Bid Addendum No. 2 for:

MASON TRANSIT AUTHORITY – PARK AND RIDE CONSTRUCTION PROJECT

All Bidders are required to make the following substitutions to the Bid Documents. Below is a description of the revisions made to the Contract Documents.

LIGHTING PLAN

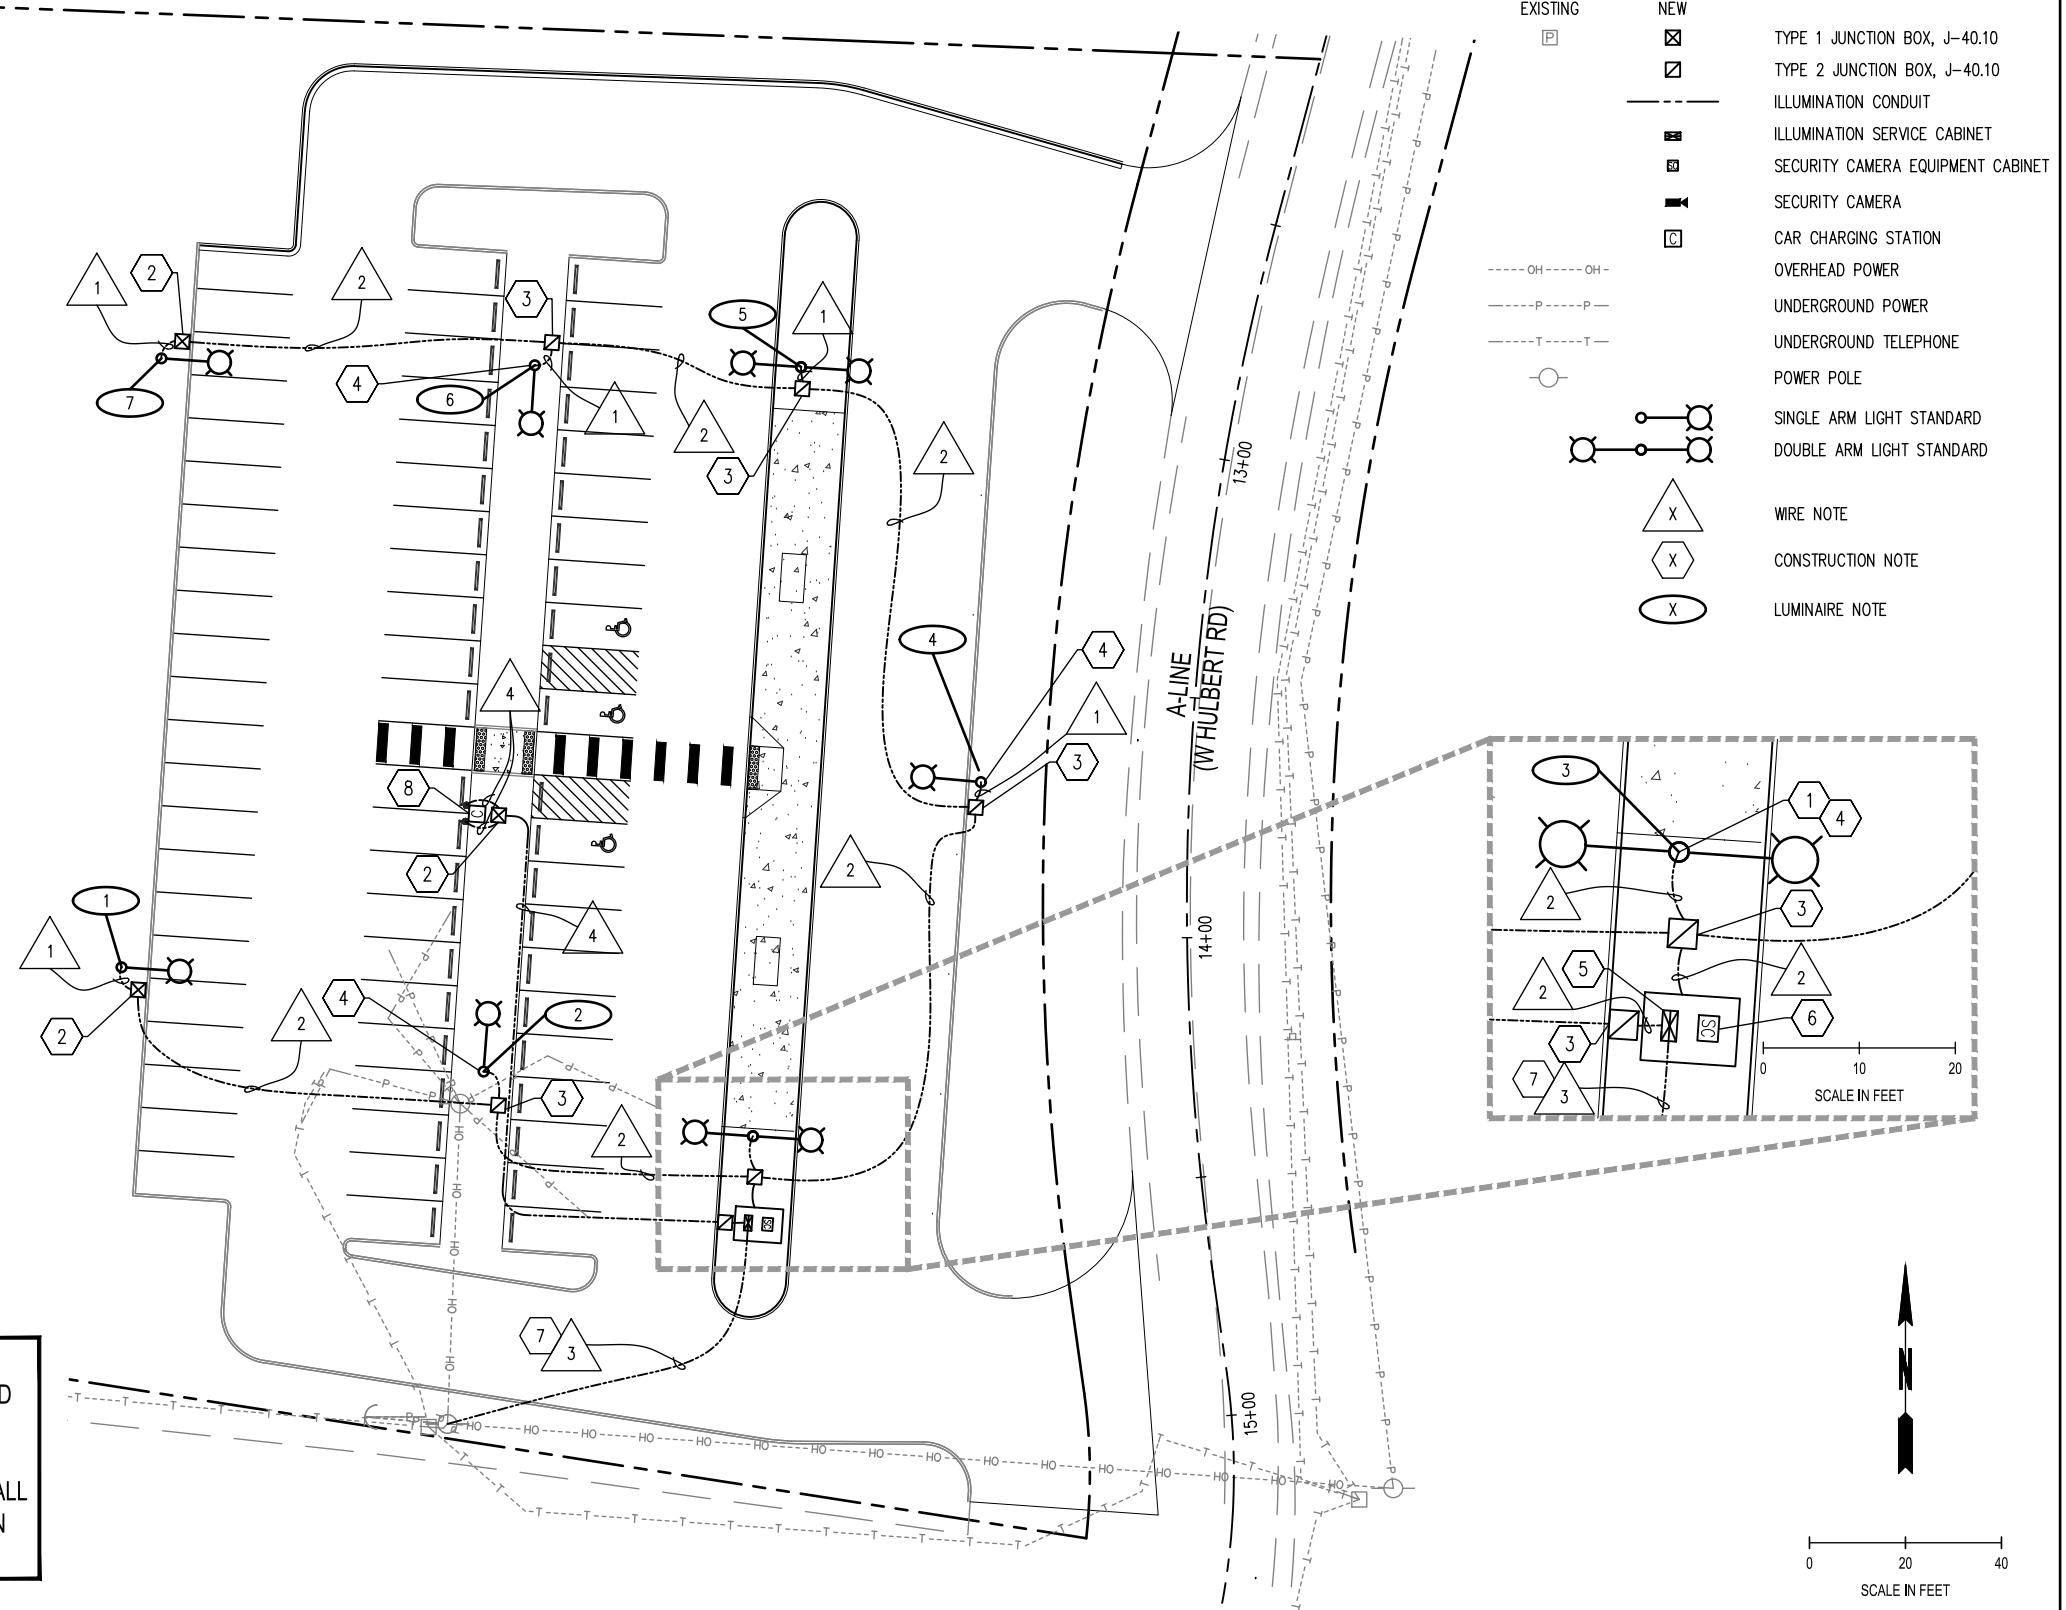
- Sheet II-1: Replace with attachment II-1 to include modified luminaire heads with security camera model.
